Project	IEEE 802.16 Broadband Wireless Access Working Group < http://ieee802.org/16 >	
Title	Enhancement of Association using SCAN-REQ/RSP — Harmonization Ad-Hoc Consensus Contribution	
Date Submitted	2004-08-17	
Source(s)	<p>Sungjin Lee, Yeongmoon Son, Jungje Son, Changhoi Koo Samsung Electronics</p> <p>Phillip Barber Broadband Mobile Technology</p> <p>Min-Sung Kim, Jeong-Hwi Kim, Seong-Choon Lee KT</p> <p>Sang-Yun Han, Jinyong Chung, Jae-Hak(Steve) Lee SOLiD Tech., Inc.</p> <p>Kisun Ryu, Yongho Kim, Kihyung Cho, Beomjoon Kim, Changjae Lee LG Electronics</p>	<p>Voice: +82 31 279 5248 steve.lee@samsung.com</p> <p>Voice: +1 (972) 365-6314 pbarber@BroadbandMobileTech.com</p> <p>Voice: +82-2-526-6109 cyberk@kt.co.kr</p> <p>Voice: +82-2-2142-3881 syhan@st.co.kr</p> <p>beom@lge.com</p>
Re:	This contribution is response to call for contribution about IEEE 802.16e-D4, Recirculation 14c	
Abstract	This document proposes the scheme enhancing scanning and association operation with SCAN-REQ/RSP

Enhancement of Association using SCAN-REQ/RSP

Figure E.3—Example Association during Scan interval by MSS request**Remedy 6:**

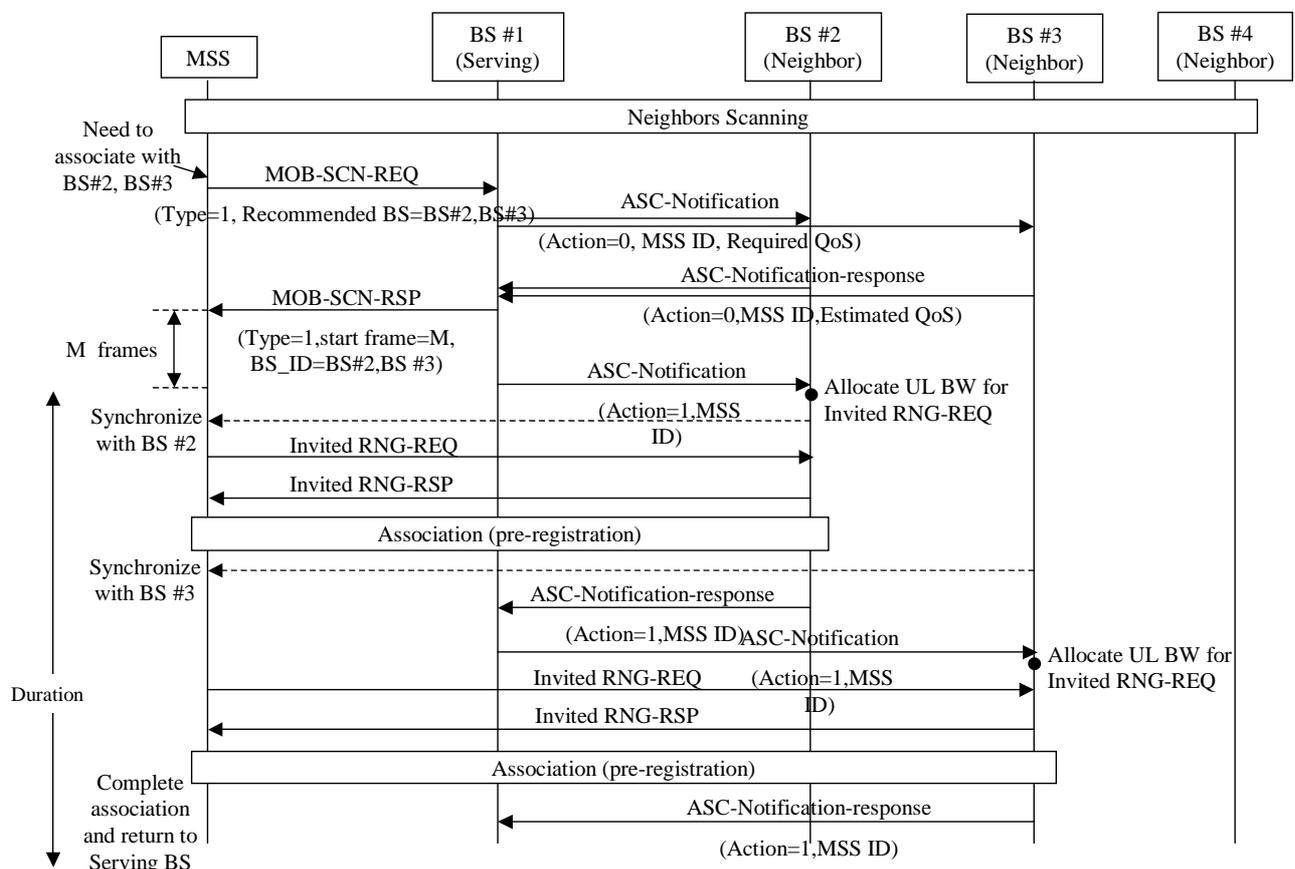
Remedy 5:

[In Annex E, page 225, line5, Add to end of section as]:

E.3 Association during Scan interval by MSS request

The following figures describe the messages flow for scanning of Available BS by the MSS request, BS request and periodic scanning of Available BS during hand-over.
